*Symbol:* EPC-DO: 17-535

*LA-UR:* 17-31181

**Subject: Transmittal of Class 1 Permit Modification Request to Remove a Refrigeration Unit from Technical Area 54, Pad 11, Dome 375**

**Class 1 Permit Modification Request to  
Remove a Refrigeration Unit from  
Technical Area 54, Pad 11, Dome 375**

**Figure G.12-1:** Technical Area 54, Area G, Pad 11 Outdoor Container Storage Unit Grid Sampling and Additional Sampling Locations

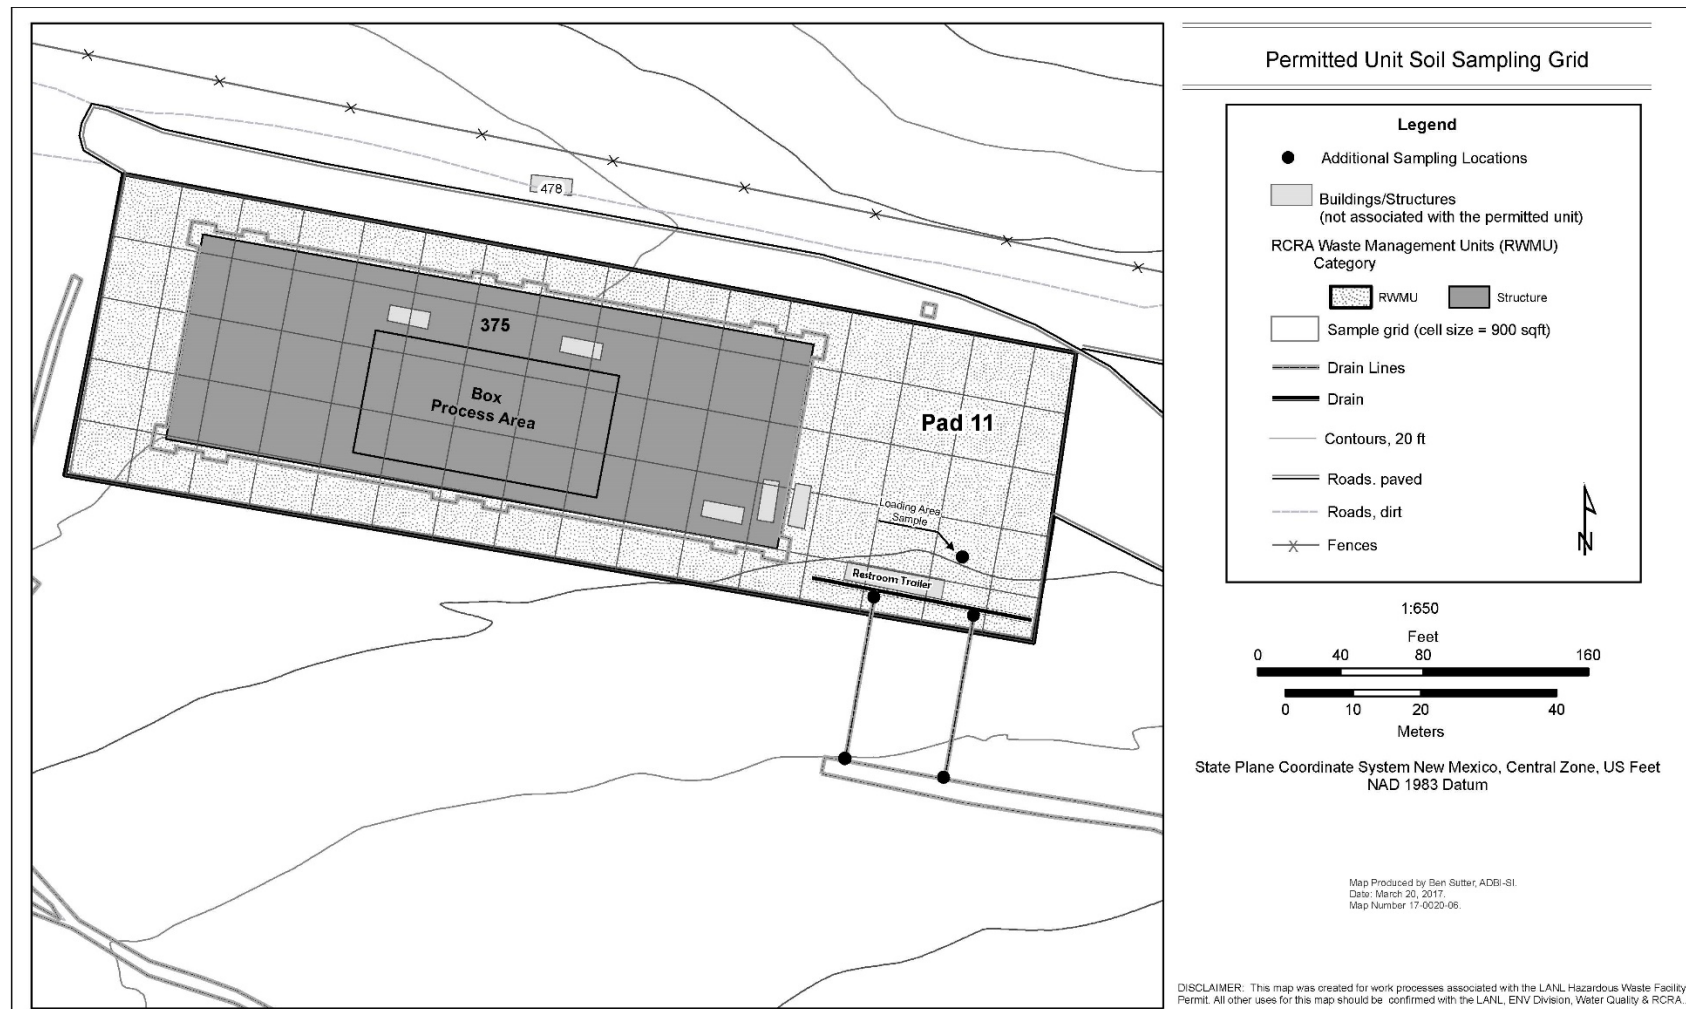
Proposed changes to the closure plan include changing the description of the refrigeration unit within Section 2.0, *Description of Unit to be Closed*, to past tense. Additionally, the refrigeration unit footprint has been removed from Figure G.12-1: *Technical Area 54, Area G, Pad 11 Outdoor Container Storage Unit Sampling Grid and Additional Sampling Locations*.

Figure 36: TA-54, Area G, Pad 11

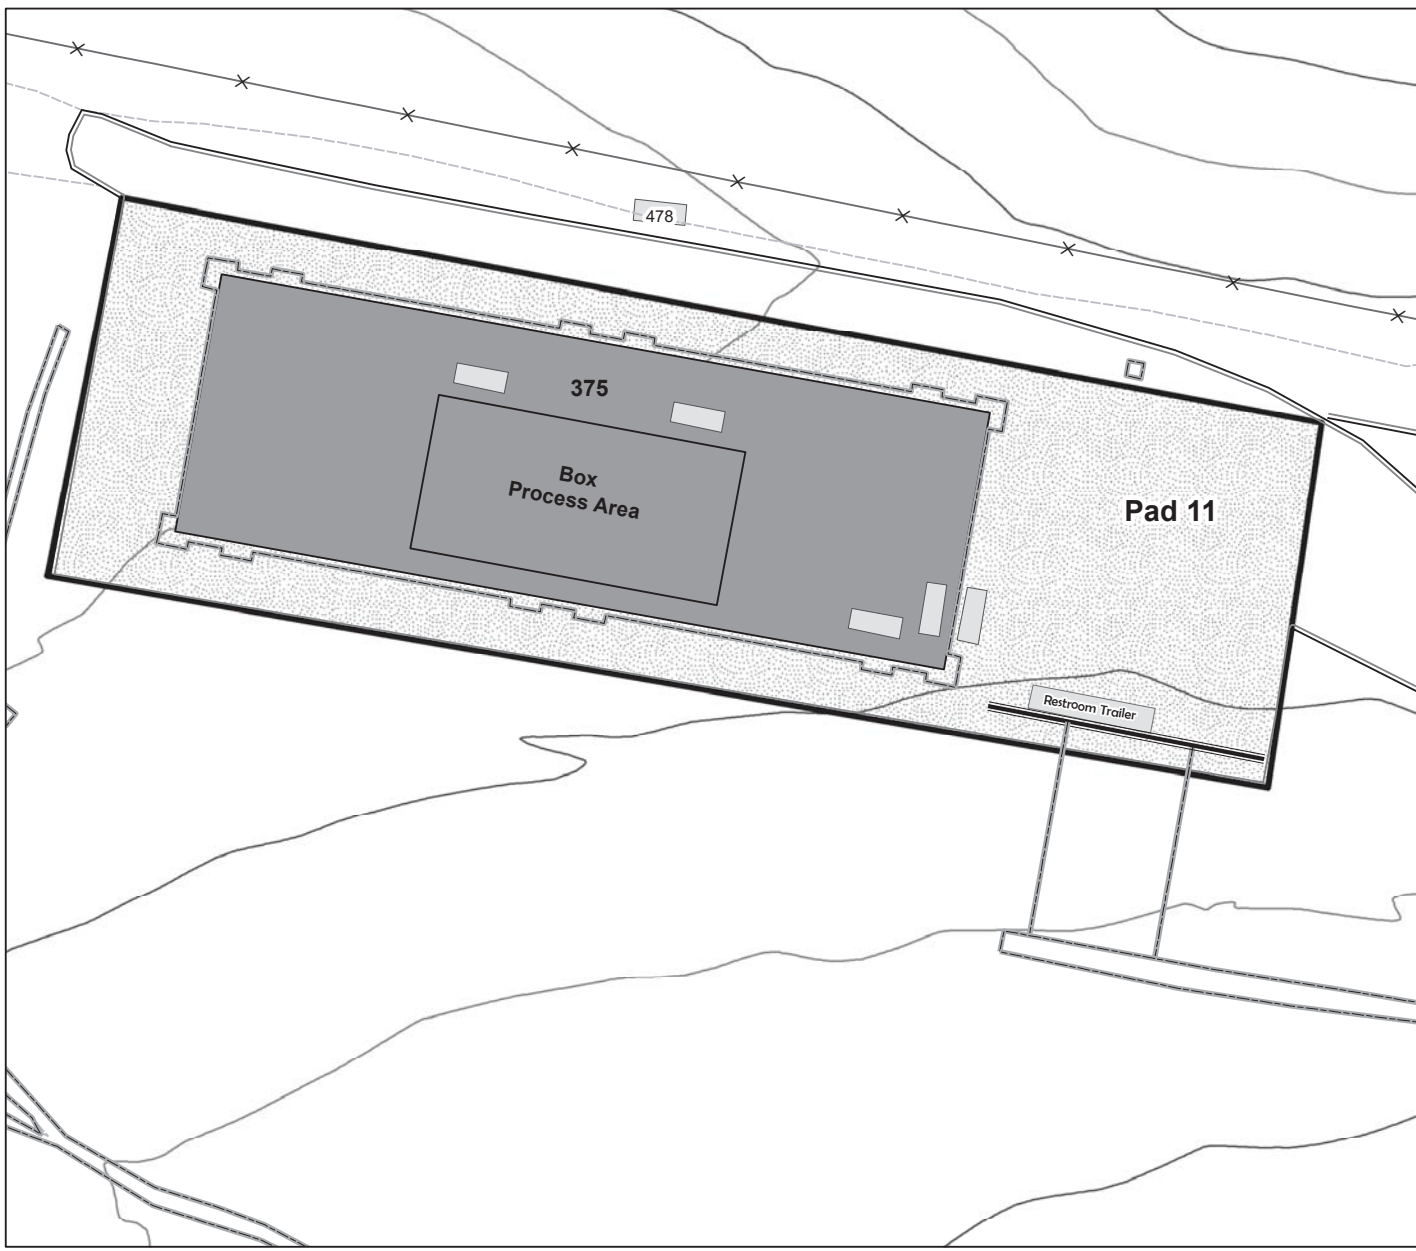
Figure 36: Technical Area (TA)-54, *Area G, Pad 11* was revised to reflect the removal of the refrigeration unit.
